**Grand Island, Nebraska
Grand Island WWTP
Headworks Improvements**

**City Project WWTP-2013-1
B&V PN 175144
OA PN 011-2347**

**ADDENDUM NO. 2
April 19, 2013**

FIGURE: AD2-1

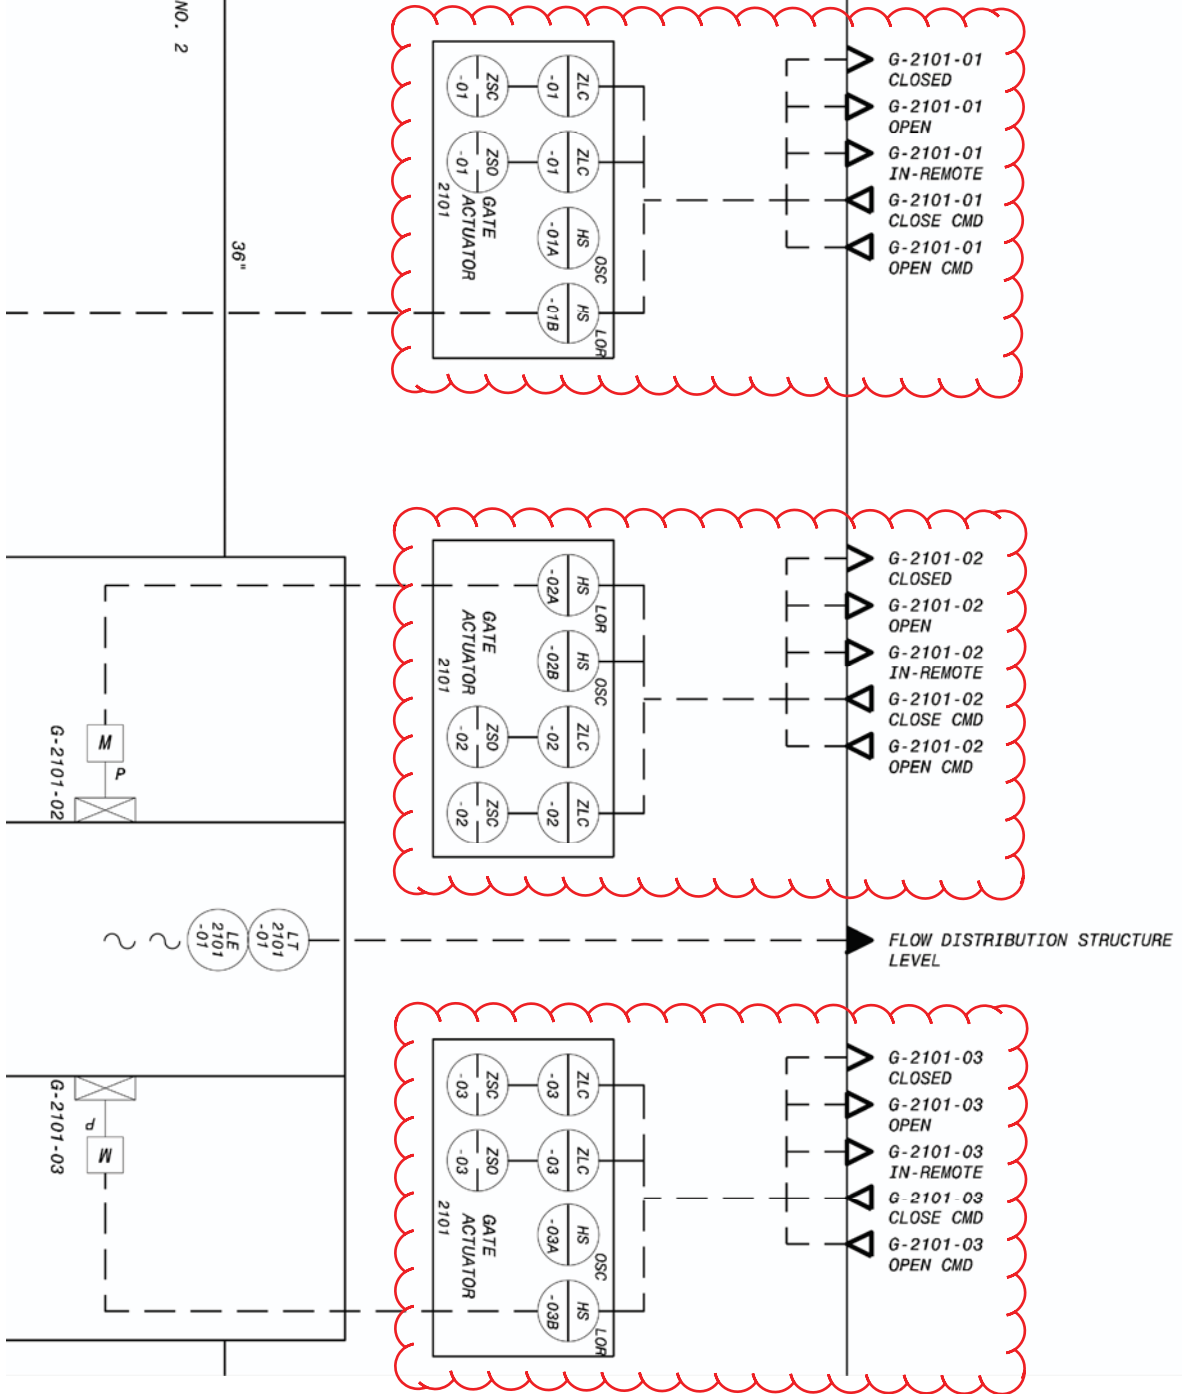
- Revised Section 13530A, Page 3
- Equipment Schedule 13570-S02 – Wall Mounted Cabinets
- Figure AD2-1: Revisions to Drawing AI8
